Memorandum to the City of Markham Committee of Adjustment

File: A/168/17
Address: 7 Towne Court, Markham
Applicant: Fanny and Isaac Chan
Agent: N/A
Hearing Date: Wednesday January 24, 2018

The following comments are provided on behalf of the Central Team. The applicant is requesting relief from the following requirements of By-law 11-72, as amended, to permit:

SITE PLAN 1:200

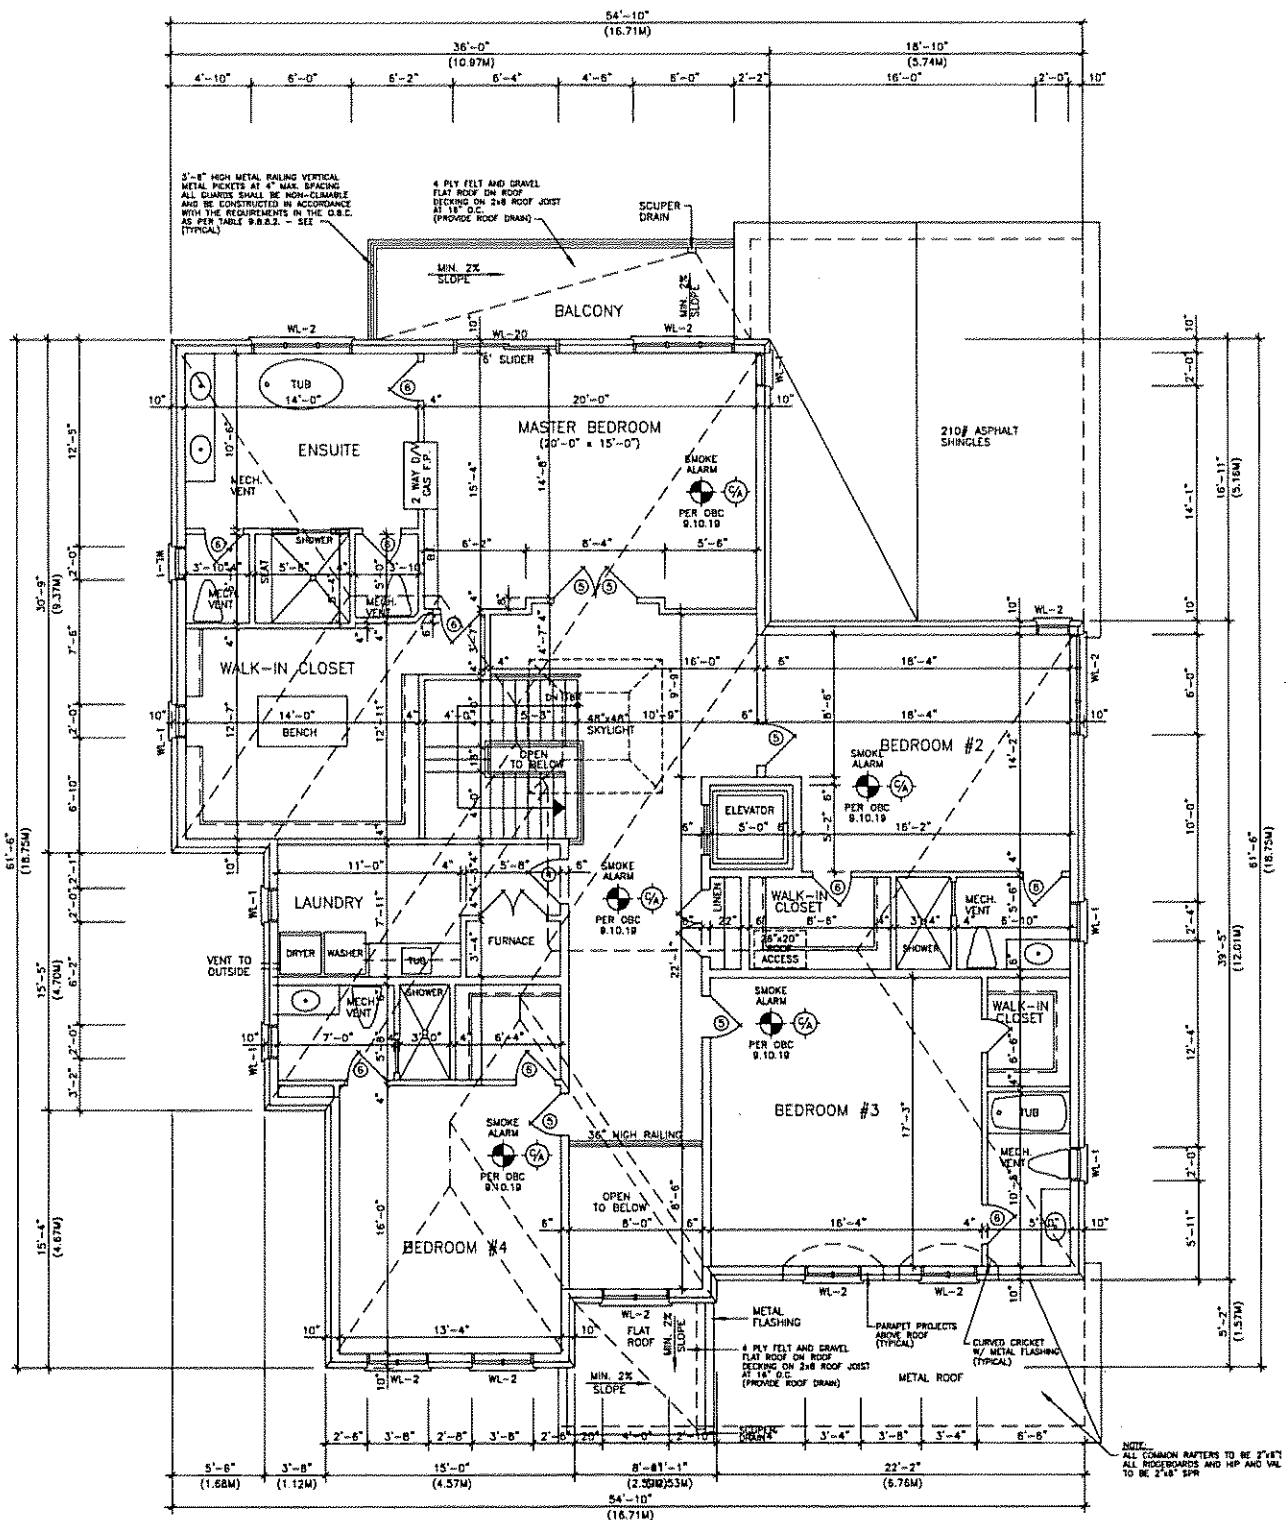
A maximum building height of 26'-5", whereas the by-law permits a maximum building height of 25'-0";

A maximum lot coverage of 35.27 percent, whereas the by-law permits a maximum lot coverage of 33.33 percent; and,

From a siting perspective, the proposed dwelling maintains all the minimum setbacks and in most instances, setbacks in excess of the minimum requirement are provided. Based on this design characteristic and given the lot orientation and configuration, variances to permit an increased building height and lot coverage are not anticipated to adversely impact the neighbouring properties or the streetscape. Staff note these variances are consistent with variances granted throughout the Varley Village community.

REAR ELEVATION

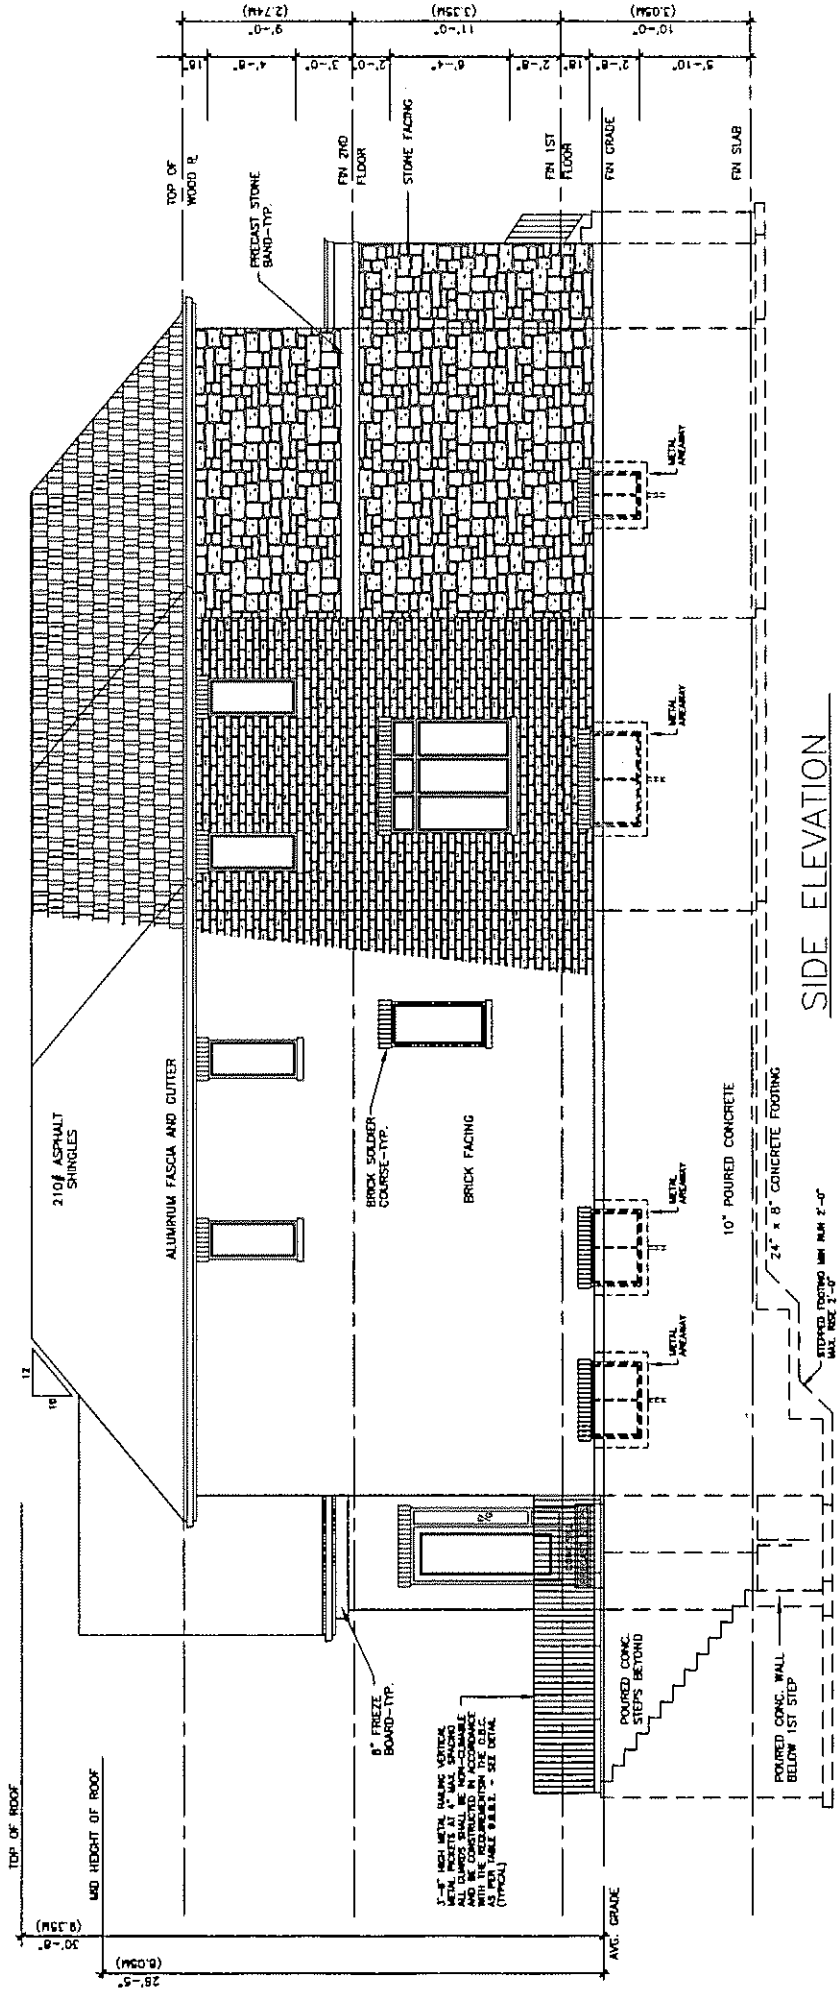
The basement walkout stairs to encroach 9'-1" into the rear yard, whereas the by-law permits uncovered platforms (including stairs) to encroach no more than 5'-0" into a front or rear yard.

The proposed basement walkout is located below grade in the portion of the rear yard which backs onto Crosby Park. The walkout maintains sizeable setbacks to the rear lot line (4.86 m) and neighbouring property to the north (5.76 m). There remains ample amenity space in the rear yard and buffering from neighbouring dwellings. For these reasons, staff do not anticipate any adverse impacts.
